IBM "Selectric"® System/2000 1

## New Individual Part Numbers

## Ribbon Lift Failure/Inability to Hold Adjustment

## ZIF Connector Operation

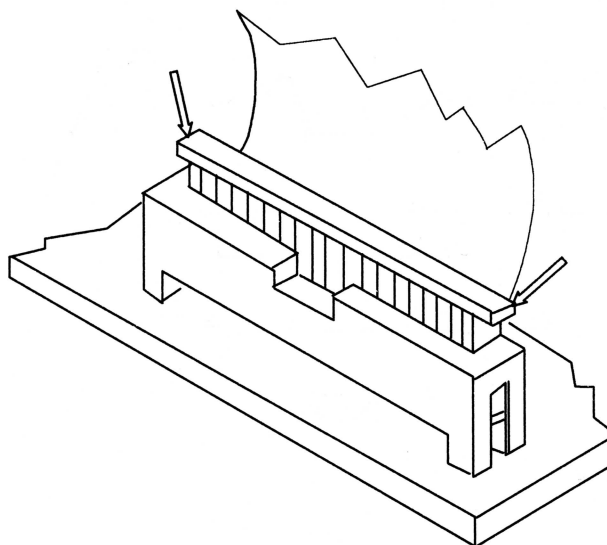
The keyboard connectors on the Function Board, used to attach the Keyboard Printed Circuit Membrane, will be changed to Zero Insertion Force (ZIF) connectors. To remove the membrane, open the ZIF connector by lifting the two extensions at each end of the connector (Figure 1). After inserting the membrane, close the connector by pressing down on the extensions until they are fully seated.

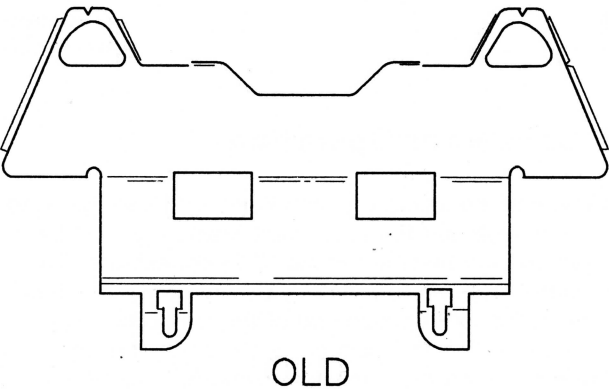
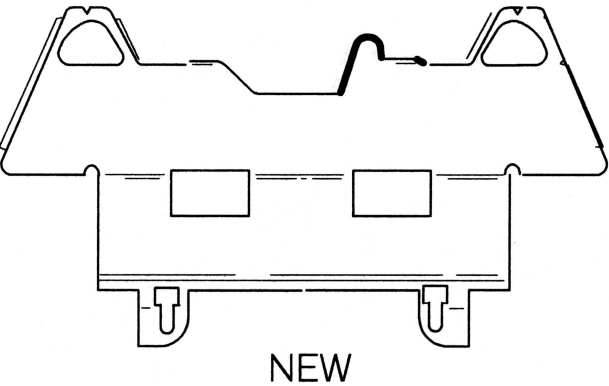
If experiencing print smearing on small envelopes or tab cards, replace with redesigned cardholder.

Note: Part number and adjustments remain the same.

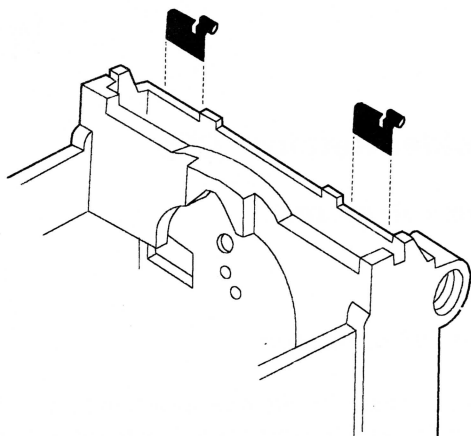
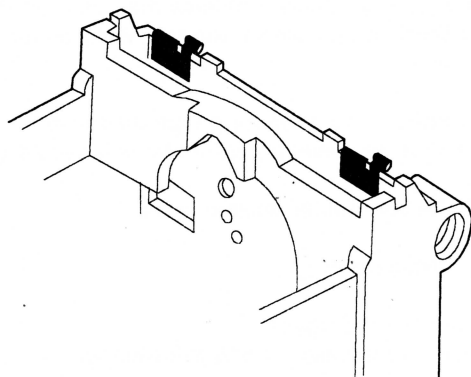
Cardholder retainer clips are now available for the IBM Wheelwriter™ 3 and 5 typewriters. The purpose of the clip is to limit the distance the cardholder can move away from the platen, under certain applications (that is, thick stock, multi-page documents, thick envelopes, etc.), and interfere with ribbon cassette movement.

If experiencing application problems that result in ribbon take-up or breakage problems, the following action should be taken:

1. Check ribbon and correcting tape diagnostics.
2. Ensure that the Level II cardholder is installed (see SM 3).
3. Install the cardholder retainer clips.

1. Lift open the top cover.
2. Remove ribbon cassette and print wheel.
3. Remove platen and deflector.
4. Move carrier to one side and remove the paper feed roller assembly (maj. 230 min. 04 or 05).
5. While holding the cardholder towards the rear, insert clips (Figure 1) on the rear carrier casting (Figure 2) with the flat side towards the front.

6. Reinstall the parts specified in Steps 2, 3, and 4.
7. Form the top of the clip to just touch the cardholder at rest.
8. Check all applications **after** installation.

## Cardholder Redesigned

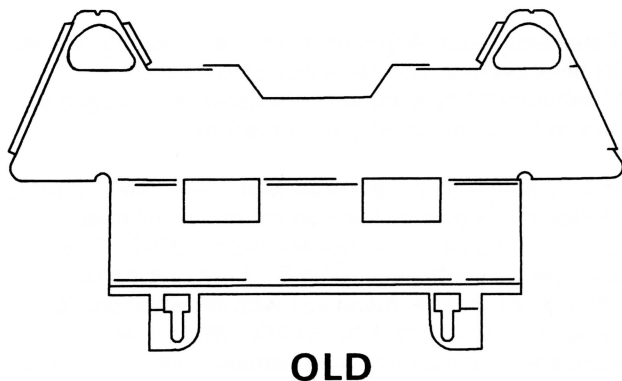
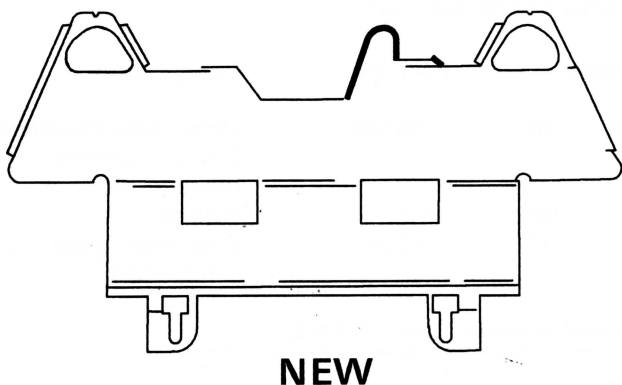
If experiencing print smearing on small envelopes or tab cards, replace with redesigned cardholder.

**Figure 1**

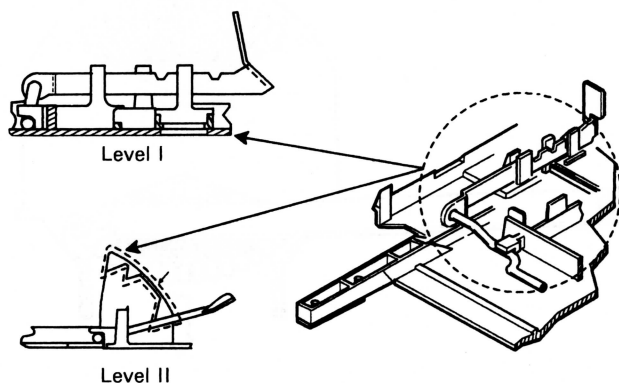
Major engineering changes are being implemented in the "Wheelwriter"™ 3 Typewriter and "Wheelwriter"™ 5 Typewriter to enhance the manufacturing process. These changes consist of a complete redesign of the electronics in the machine. The typewriters' outward appearance and function remain unchanged. The "Wheelwriter" Typewriter Maintenance Library has been updated to reflect these changes. You must order form number S544-4047-2 from Mechanicsburg to obtain the updated Maintenance Library. To ensure that you are using the correct diagnostic procedures, you must verify which level of machine you are servicing. Service represen-

tatives can readily identify a Level II machine by the redesigned keyboard height adjusting lever (Figure 1).

## Cardholder Retainer Clip

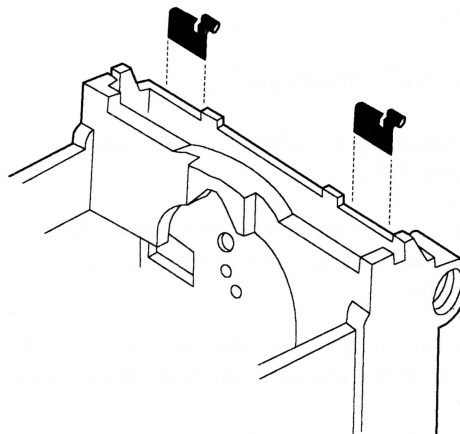
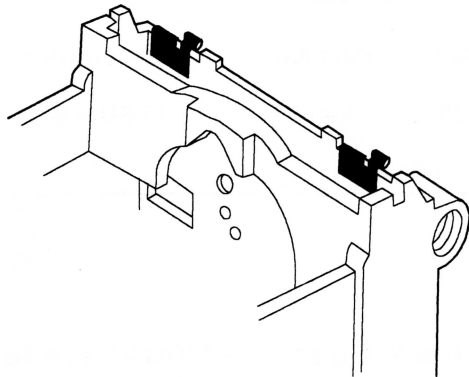
1. Check ribbon and correcting tape diagnostics.
2. Ensure that the Level II cardholder is installed (see SM 3).
3. Install the cardholder retainer clips.

1. Lift open the top cover.
2. Remove ribbon cassette and print wheel.
3. Remove platen and deflector.
4. Move carrier to one side and remove the paper feed roller assembly (maj. 230 min. 04 or 05).
5. While holding the cardholder towards the rear, insert clips (Figure 1) on the rear carrier casting (Figure 2) with the flat side towards the front.
